Preliminary Engineering Report Amendment for RiverRenew

Prepared for
Virginia Department of Environmental Quality

December 31, 2019

Figure 2-1. Dual-Shaft TDPS and WWPS Configuration

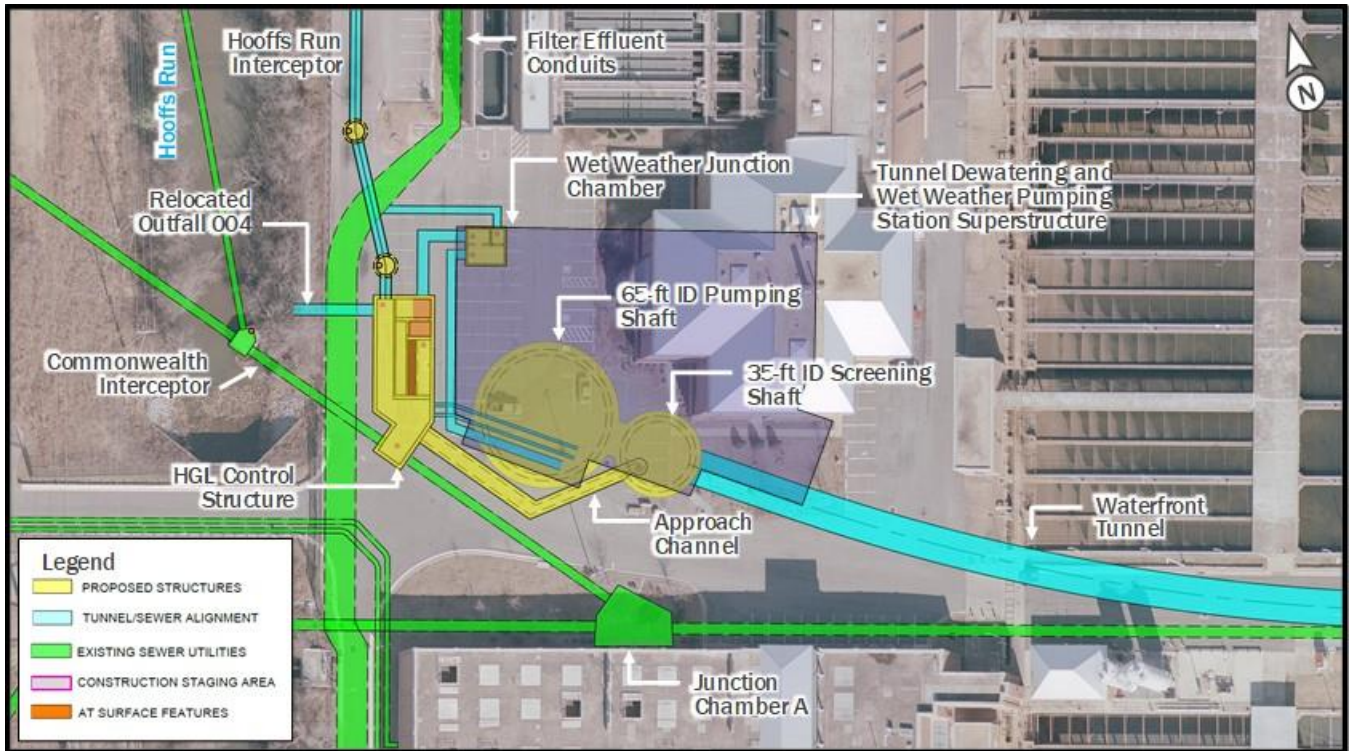
In order to mitigate the identified challenges, the design of the TDPS was modified to a dry well/wet well style pumping station, and the WWPS was relocated to be installed within the drywell of the new TDPS in a single Pumping Shaft. The amended technically preferred alternative, shown in Figure 2-1 and Figure 2-2, offers several benefits which are summarized below:

- Co-locating the TDPS and WWPS into a single 65-ft inside diameter Pumping Shaft provides a centralized location for all tunnel system pumping facilities.

- Dual-shaft configuration (Pumping Shaft and Screening Shaft) allows for the construction of a Hydraulic Institute (HI) compliant pumping station and trench style wet well, while also maintaining the integrity of the expedited construction schedule. The smaller 35-ft inside diameter Screening Shaft may be constructed first and utilized to launch the tunnel boring machine for construction of the Waterfront Tunnel, to preserve the critical path of the construction schedule.

- Pumps are more easily accessible for operation and maintenance staff.
- Avoidance of a trenchless excavation in unfavorable geotechnical conditions. (New pipelines to the WWPS may be installed via open cut with minimal impacts to utilities.)

- Flow to the Wet Weather Treatment (WWT) Facility would only need to be pumped once.
- Pump vibrations/harmonics will be minimized due to sufficient concrete mass in the shaft.
